Modification of products

Pushbutton switch / Indicator

NO.ZA - SOT - 0412195

Pushbutton switch Model A16, Indicator Model M16 series (Separate type)
Change of shipping schedule and additional indication.

Change of Pushbutton unit (For I P 6 5 type only - Not include I P 4 0 type)

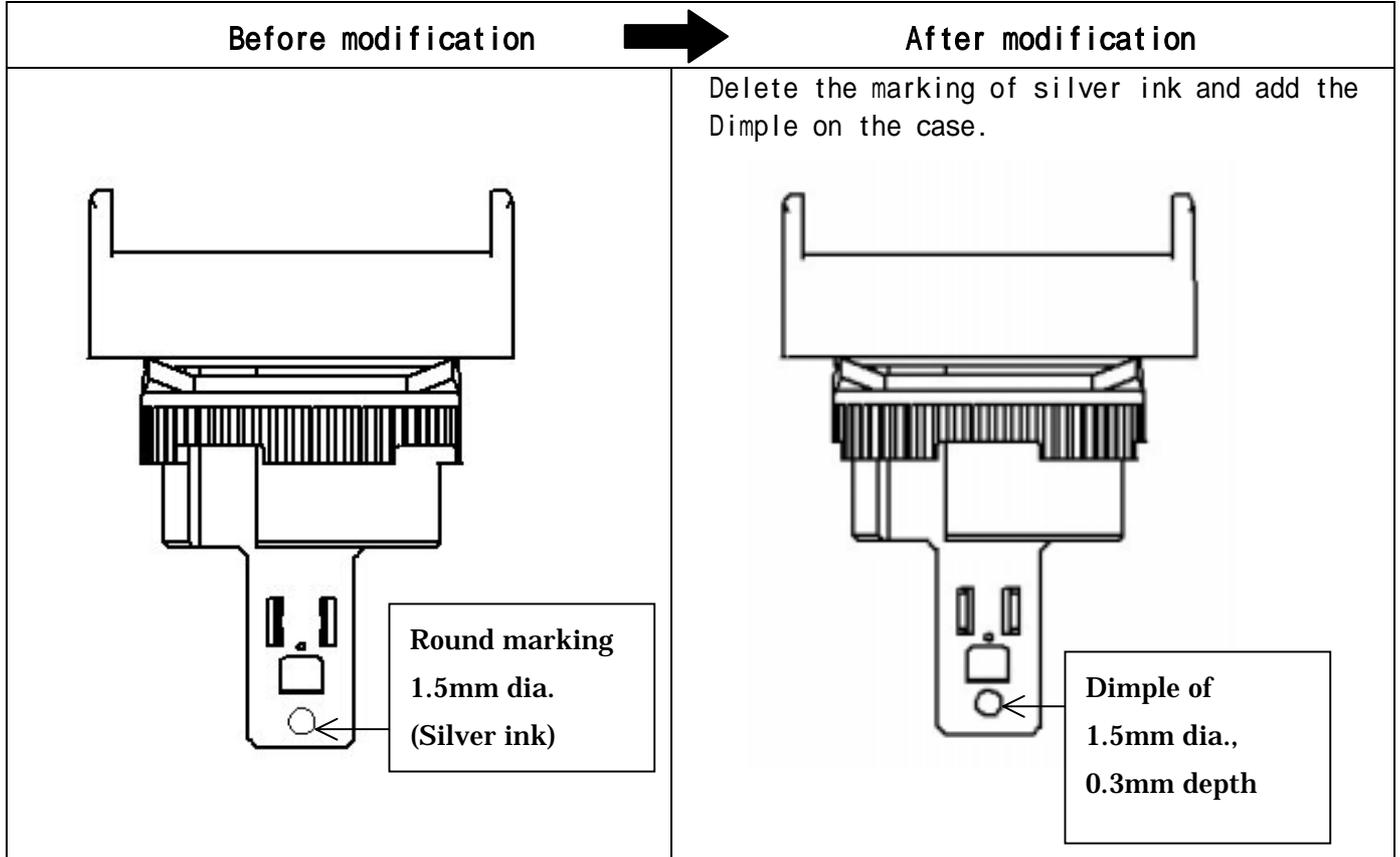
Change of Indication for the direction of Case Unit
